Application No. 10/803,174

**AMENDMENTS TO THE DRAWINGS**

**REMARKS**

FIG 10

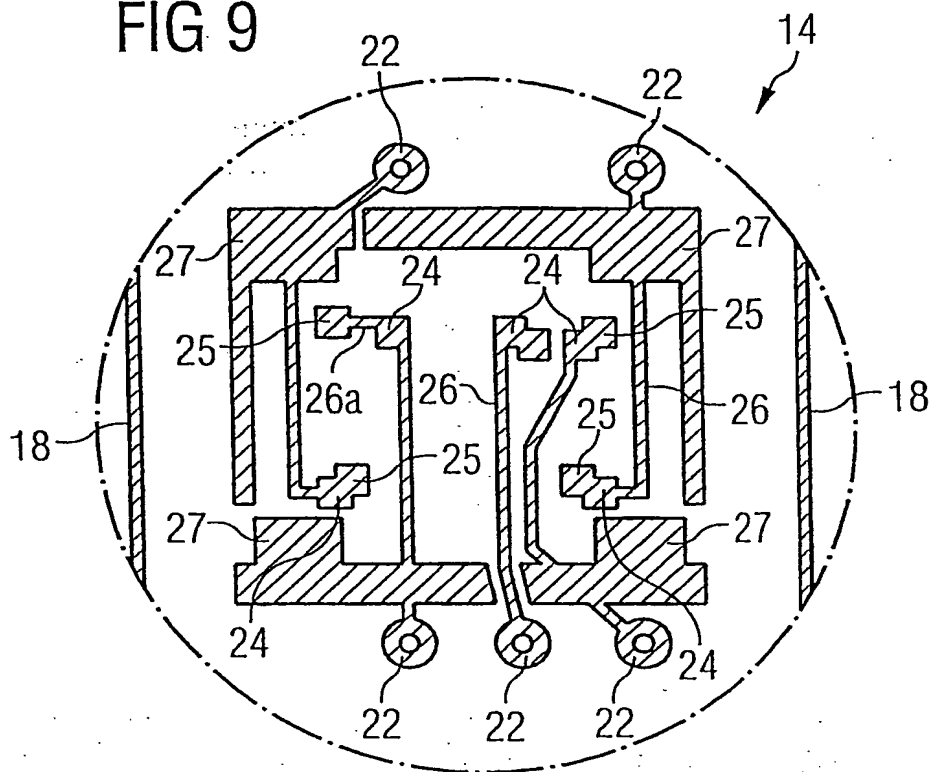
The attached sheet of drawings includes changes to Figure 10.

The drawings were objected to under 37 C.F.R. § 1.83(a). Applicants have amended claim 10 which now shows the spacer of claim 24. The spacers are designated as reference numeral 60. Applicants respectfully request acceptance of the revised Figure.
